2015 - 2016 Corvette: Service Bulletin: #16-NA-014: Delayed Engagement After Sitting With Engine Off

#16-NA-014: Delayed Engagement After Sitting With Engine Off - (Jun 28, 2016)

Subject: Delayed Engagement After Sitting With Engine Off

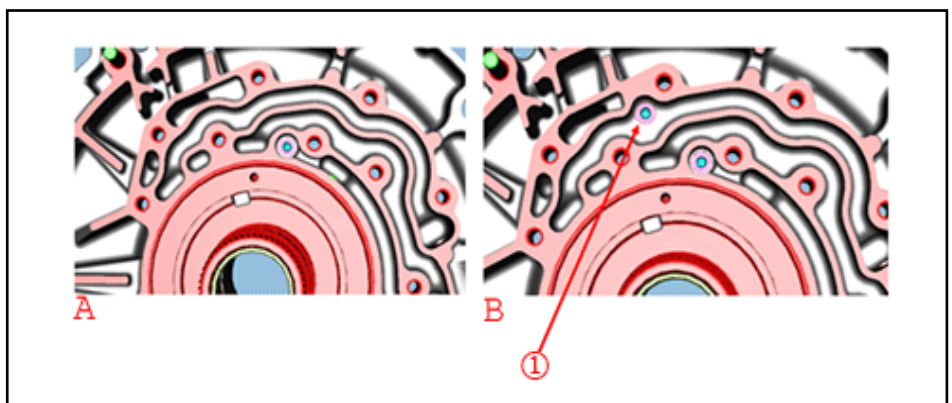
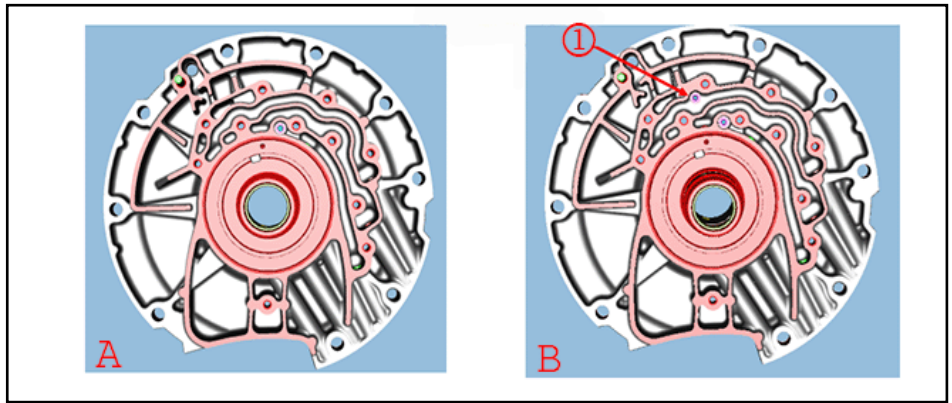
(A)

Old stator support asm

(B)

New stator support asm

Note: The new stator shaft support assembly has a second check ball (1) added (see illustrations).

Install a new stator shaft support assembly that includes an additional check ball. Follow the instructions below to replace the stator shaft

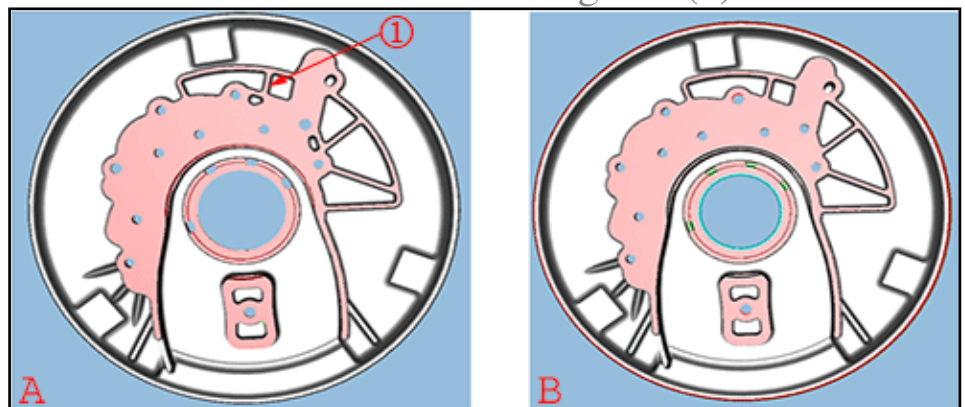
(A)

Old cover - 8L90 Only

(B)

New cover - 8L90 Only

Note: The casting void has been eliminated from the underside of the cover for the 8L90 only (see illustration). The 8L45 is not required.
